ALERT SERVICE BULLETIN

429-15-26
7000000141
7 December 2015

MODEL AFFECTED: 429

SUBJECT: TAIL ROTOR PITCH LINK CORROSION
INSPECTION, INTRODUCTION OF

Figure 1 - Pitch Link Corrosion

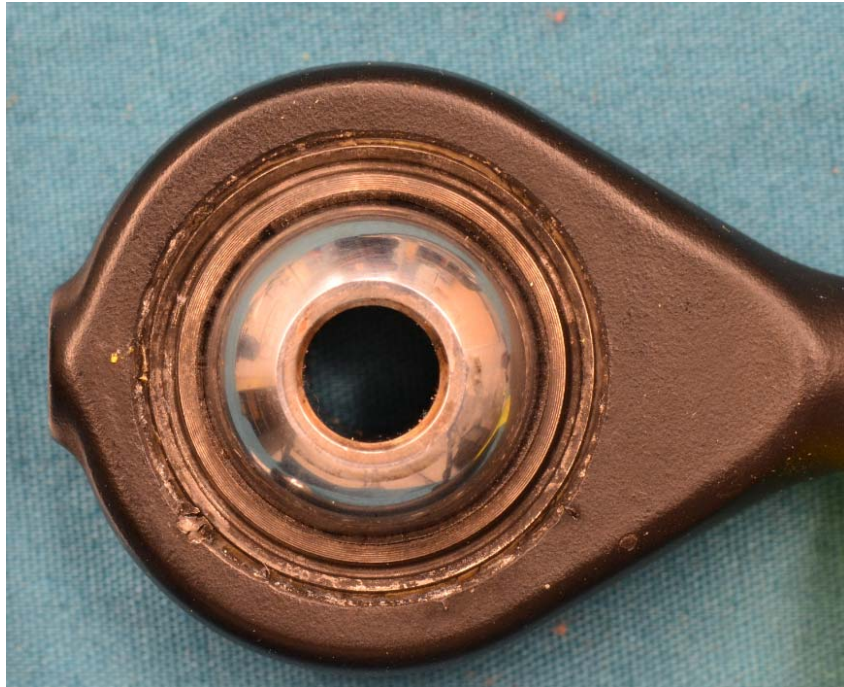
Bell Helicopter has received reports of corrosion on tail rotor pitch links present between the roll staked lip of the 429-312-107-103 bearing and the beveled edge of the 429-012-112-101/-103 tail rotor pitch link. **Part I** of this bulletin introduces an inspection for corrosion and the application of sealant. **Part II** of this bulletin introduces

3. Use 10X magnification to inspect all eight tail rotor pitch link bearing bores for corrosion evident by the presence of aluminum oxide extruding from between the roll staked lip of the bearing outer race and the pitch link bearing bore (Figure 1). If corrosion is found, replace the affected pitch link.

4. If no corrosion is found in the previous step, clean the area thoroughly with isopropyl alcohol (C-285) and inspect using 10X magnification. If corrosion is found, replace the affected pitch link.

5. If no corrosion is found in the previous step, remove any traces of torque stripe and clean the affected area with isopropyl alcohol (C-285). Apply corrosion preventative sealant (C-251) MIL-PRF-81733 to the bearing roll stake lip and the pitch link (Figure 2). Make sure that there are no pin holes or voids in the sealant. The thickness of the sealant should not exceed 0.025 inch (0.64 mm), should extend

over roll staked lip by 0.030 inch (0.76 mm) min and remain clear of the bearing ball.
